Project: **RFQ-1202-2025**
Project Name: University Hall HVAC Upgrade
Project Number: 20020136
Date: August 29, 2025
Page: 1

Project Name: McMaster University – University Hall Ventilation Upgrade

Title: Mech/Elec Addendum 02
Reason for Change: Revisions to capture additional addendum questions

6 LIGHT
E3-03 N.T.S.

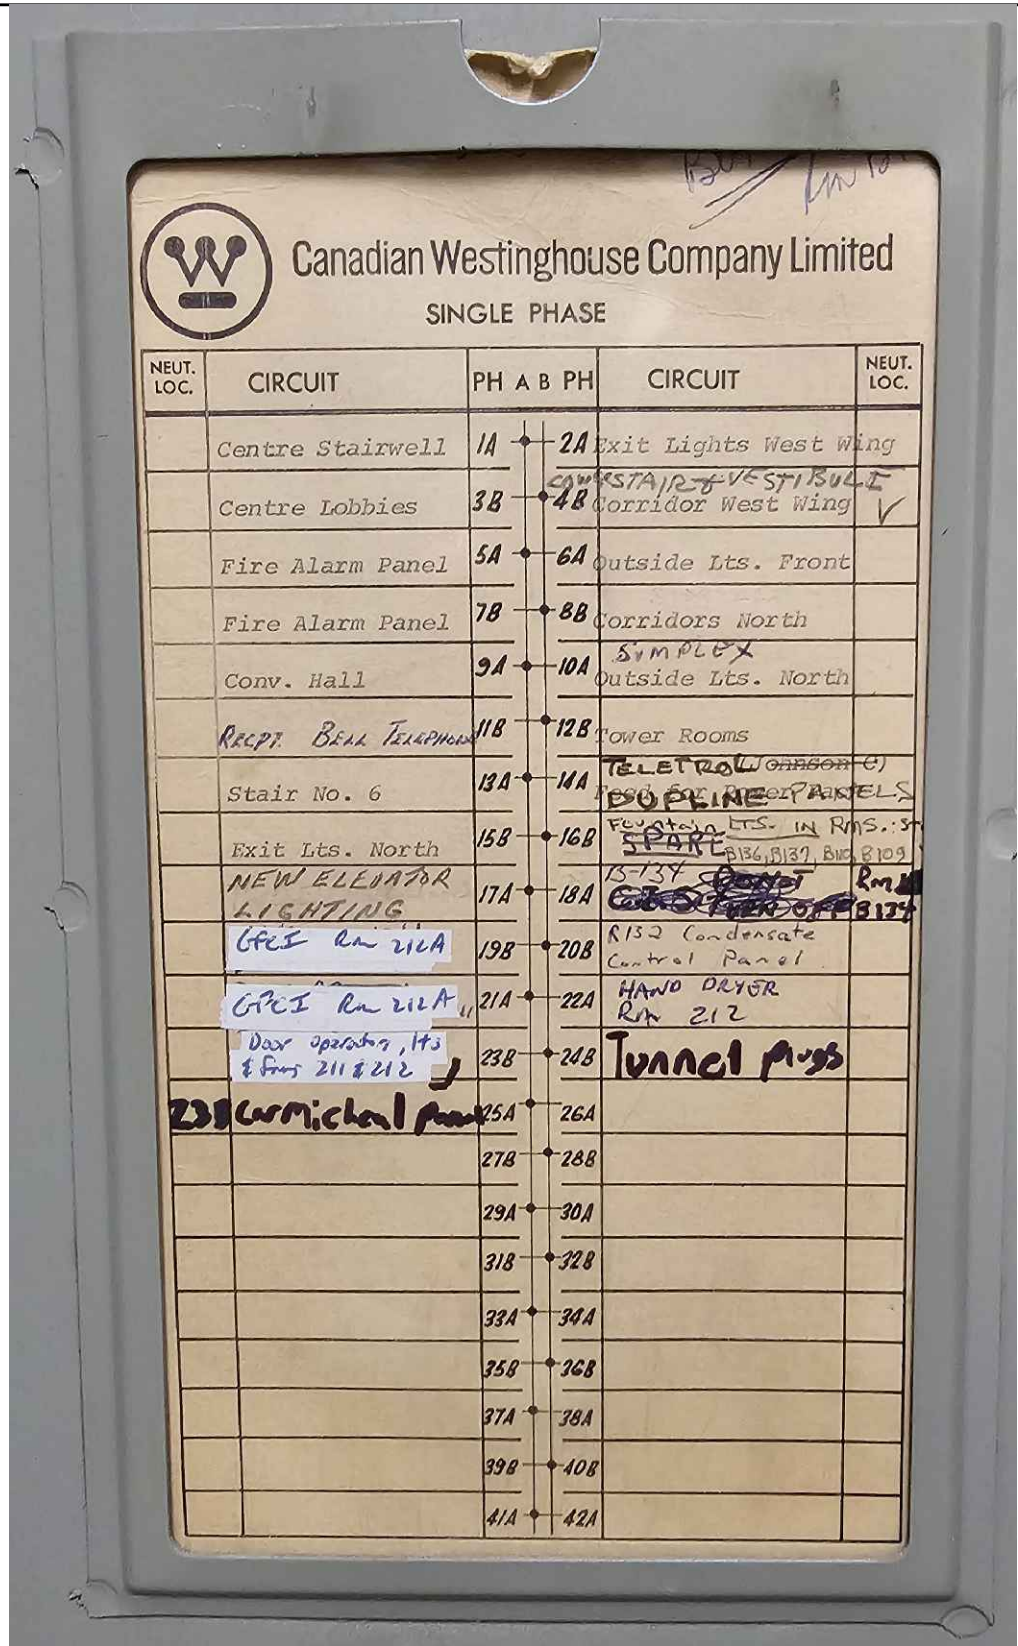
Drawing #	Revisions
E3-03	<ul style="list-style-type: none">• Added photos in detail 5 to show existing panel ESP• Added photo in detail 6 to provide additional details for conduit rework and lighting replacement in rm 122.
